# Assessment report to Sydney Central City Planning Panel

Panel reference: 2018SWC024 DA

| <b>DA number</b>            | SPP-17-00040   | <b>Date of lodgement</b>     | 7 November 2017 |
| <b>Proposed development</b> | Alterations and additions to an existing school, including construction of a 2 storey learning building with outdoor learning areas to replace the existing demountable classrooms and alterations to an existing building including an administration wing. |                              |                 |

Figure 1 Trees proposed for removal

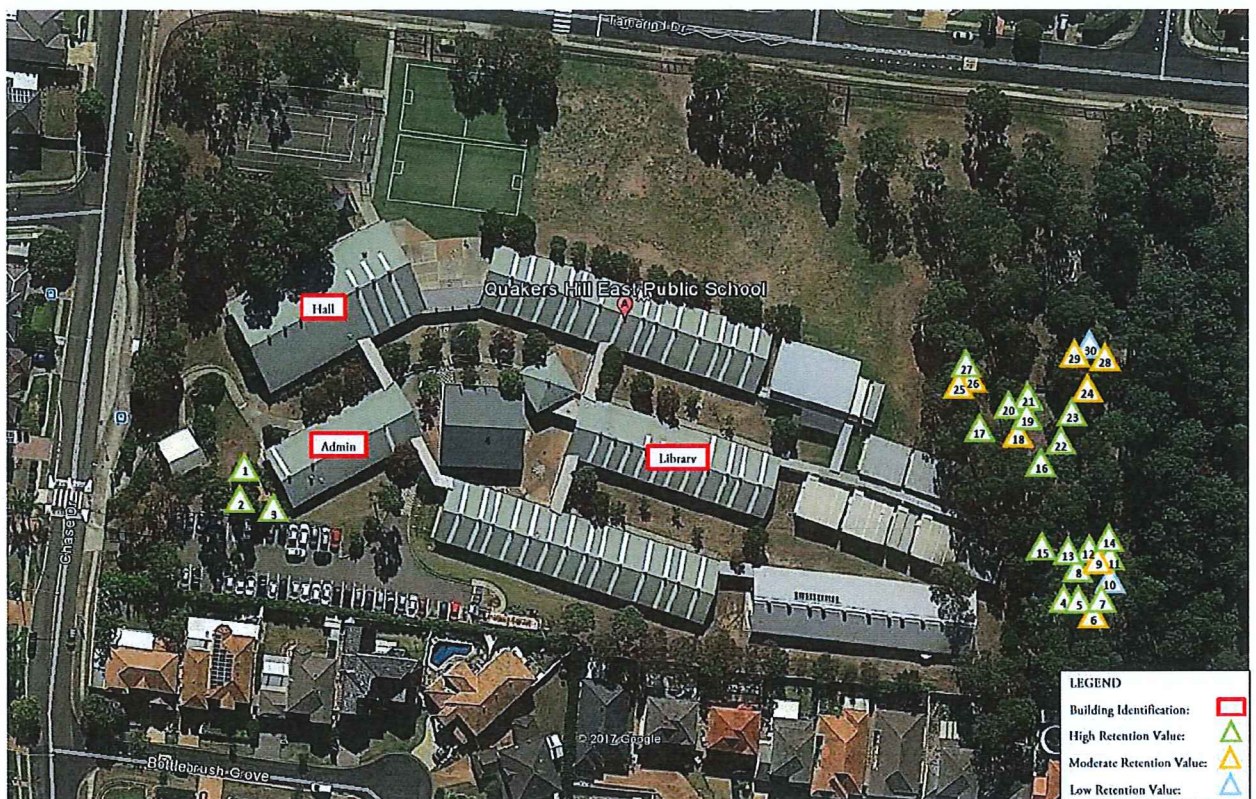
- 7.2.1 The proposal requires the removal of 24 trees from the site to accommodate the additional learning building, associated outdoor learning areas and landscaped area, and the additions to the administration building. Of the 24 trees proposed for removal, 19 have been identified as having a high retention value.

- 7.2.2 A Preliminary Tree Assessment Report was submitted with the application which identified the trees for removal (Figure 1). In addition, a Flora and Fauna Assessment Report was submitted with the application as the site is identified in BLEP 2015 as containing Terrestrial Biodiversity. Whilst it would have been desirable to retain these trees and place the new development on the existing cleared area, this would significantly reduce the outdoor playing area for the school children. On this basis the removal of trees is reasonable in the circumstances.

- 7.2.3 The Flora and Fauna Assessment Report has been reviewed by Council's Open Space and Biodiversity Officer. No objection has been raised to the tree removal subject to the imposition of a condition of consent requiring a Vegetation Management Plan being submitted to Council for approval prior to the issue of the Construction Certificate.
